Access Compliance Report

Public Rights-of-Way

(Curb Ramps)

Intersection ID: N/A	Main Street: NORTHLAKE CENTRE PY	Cross Street: N/A	Location: NE
ADA ID: 48B97F4D305E	Ramp Type: Perp	Initial Pass/Fail: Fail	Overall Compliance: No
Codes/Mitigation Info/Possible Solution		Field Measurements/Component Compliance	
Severity Score: 21.25

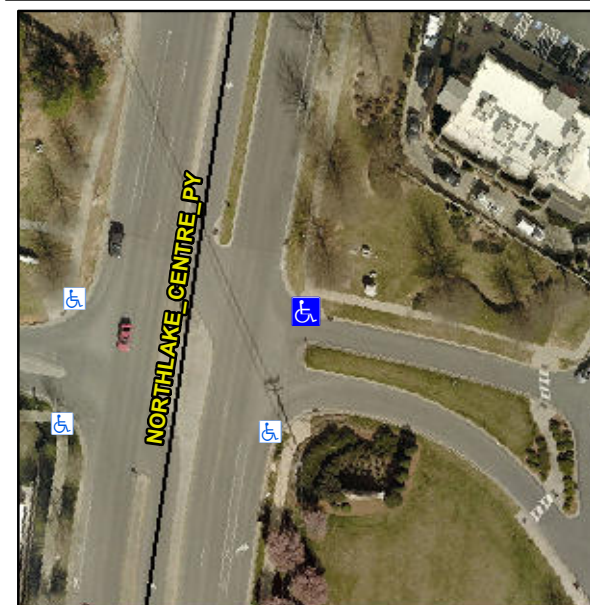
Compliance	Description	Data	Compliance	Description	Data
N/A	Ramp Length (in)	110.0	No	Ramp Slope (%)	8.5
No	Ramp Width (in)	44.0	Yes	Ramp XSlope (%)	0.4
N/A	Flare Type LT	N/A	N/A	Flare Type RT	N/A
N/A	Flare Slope LT (%)	N/A	N/A	Flare Slope RT (%)	N/A
N/A	Flare Traversable LT?	No	N/A	Flare Traversable RT?	No
N/A	Landing Length (in)	N/A	N/A	DWS Provided?	N/A
N/A	Landing Width (in)	N/A	N/A	DWS Contrast?	N/A
N/A	Landing Slope (%)	N/A	N/A	DWS Length (in)	N/A
N/A	Landing X Slope (%)	N/A	N/A	DWS Full Width?	N/A
N/A	Landing Curb? (Y/N)	N/A	N/A	DWS Offset (in)	N/A
N/A	Shared Landing?	N/A			
N/A	Gutter Ponding?	N/A	N/A	Gutter Slope (%)	N/A
N/A	Gutter Lip Ht (in)	N/A	N/A	Gutter X Slope (%)	N/A
N/A	Painted X Walk1?	No	N/A	Painted X Walk2?	N/A
	X Walk 1 Direction	To S		X Walk 2 Direction	N/A
N/A	X Walk 1 Width (in)	N/A	N/A	X Walk 2 Width (in)	N/A
	X Walk 1 Slope (%)	2.3		X Walk 2 Slope (%)	N/A
	X Walk 1 X Slope (%)	1.3		X Walk 2 X Slope (%)	N/A

Remove & Replace Entire Ramp.
